Working Party on the Transport of Dangerous Goods

**Proposals for amendments to annexes A and B of ADR:
construction and approval of vehicles**

Safety considerations in the use of liquefied natural gas (LNG) as fuel for vehicles carrying dangerous goods: Responses to ECE/TRANS/WP.15/2015/4 Transmitted by the Government of Germany and ECE/TRANS/WP.15/2015/INF.3, Compressed Natural Gas (CNG) as fuel for vehicles carrying dangerous goods by the Government of Sweden.

Transmitted by the NGV Global (the International Association for Natural Gas Vehicles)

Figure2: Provisions on LNG identification mark for vehicles of categories M2 and M3, N2 and N3

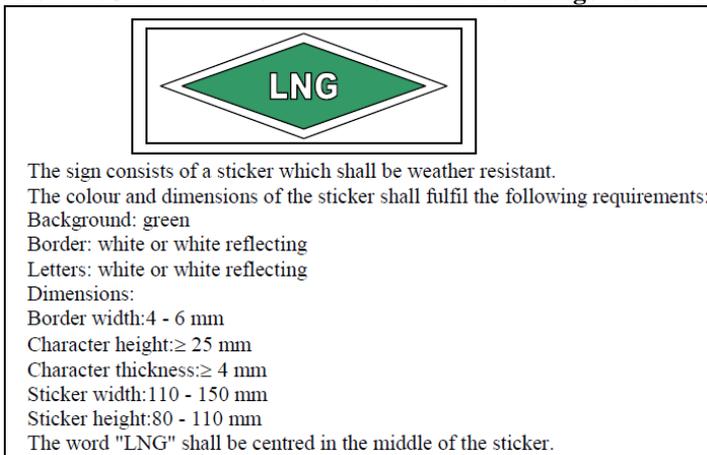
Item 9 (e): Fire of the vehicle (tire fire, fire in the engine), of flammable substance transported in the tank or fire around the vehicle (for example accident of other vehicles) with a release from or a serious damage of the LNG fuel tank. Sweden also is concerned that, in case of an incident or accident, it should be of uttermost importance for the

- Shall the emergency response forces be informed about the additional danger, that there is an LNG fuel tank on board the vehicle carrying dangerous goods?

Response: For clarification, there is no ‘additional danger that there is an LNG fuel tank on board’ although there may be *different* safety considerations than from diesel fuel. We fully agree that emergency responders should be fully informed and trained on the appropriate actions that need to be taken in case of a fire on a truck carrying LNG.

Furthermore, Regulation 110 Annex 7 requires N2 and N3 LNG vehicles to have specific labelling on the rear and front of the vehicles in order to alert emergency response forces to identify that the vehicle is fuelled by something other than diesel. (Annex 6 prescribes labelling of M2 and M3 CNG vehicles.) . Figure 2 shows the LNG signage and specifications for trucks.
